**INSERT THIS PAGE IN FRONT OF VOLUME 6**

<b>Volume 6: SECTION 3.4</b>	
<b>Remove</b>	<b>Replace</b>
3.4.1 ITS pg 3.4-1 Rev 2	3.4.1 ITS pg 3.4-1 Rev 4
3.4.1 CTS M/U (3/4 4-2) pg 3 of 6	3.4.1 CTS M/U (3/4 4-2) pg 3 of 6 Rev 4

3.4 REACTOR COOLANT SYSTEM (RCS)

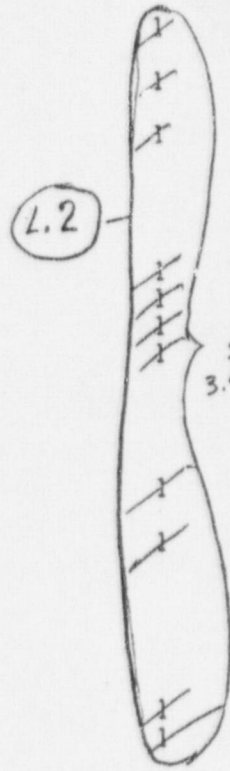
SR 3.4.5.1.b { 0.4<sup>(a)</sup>  
0.4<sup>(a)</sup>  
SR 3.4.5.1.c { 10  
10

SR 3.4.5.1.b

RAI 6

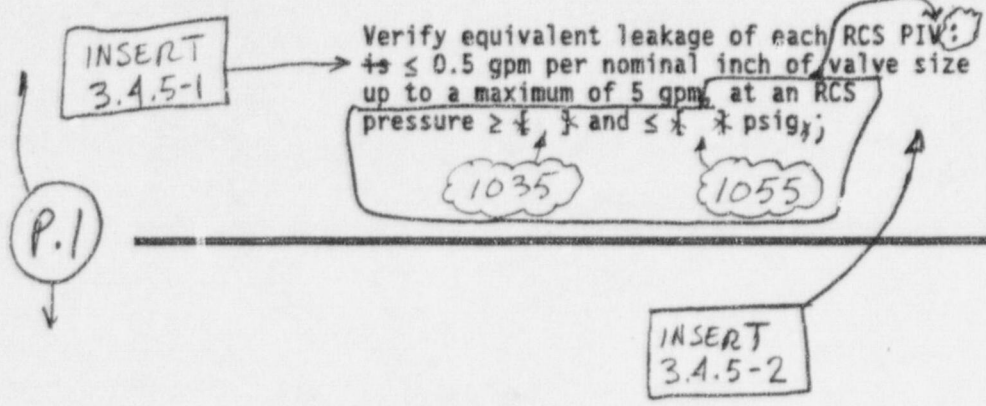
SURVEILLANCE	FREQUENCY
<p>SR 3.4.5.1</p> <p>-----NOTE----- Not required to be performed in MODE 3.</p> <p>Verify equivalent leakage of each RCS PIV:  <del>is</del> <math>\leq 0.5</math> gpm per nominal inch of valve size                      up to a maximum of 5 gpm, at an RCS                      pressure <math>\geq</math> * * and <math>\leq</math> * * psig;</p>	<p>&lt;4.4.3.2.2&gt; &lt;3.4.3.2.d&gt;</p> <p>In accordance with the Inservice Testing Program or                      18 months</p>

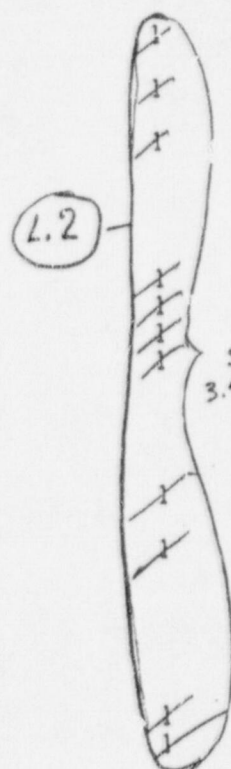
SR 3.4.5.1.b { 0.4<sup>(a)</sup>  
0.4<sup>(a)</sup>  
TO  
SR 3.4.5.1.c { 10

SR 3.4.5.1.b
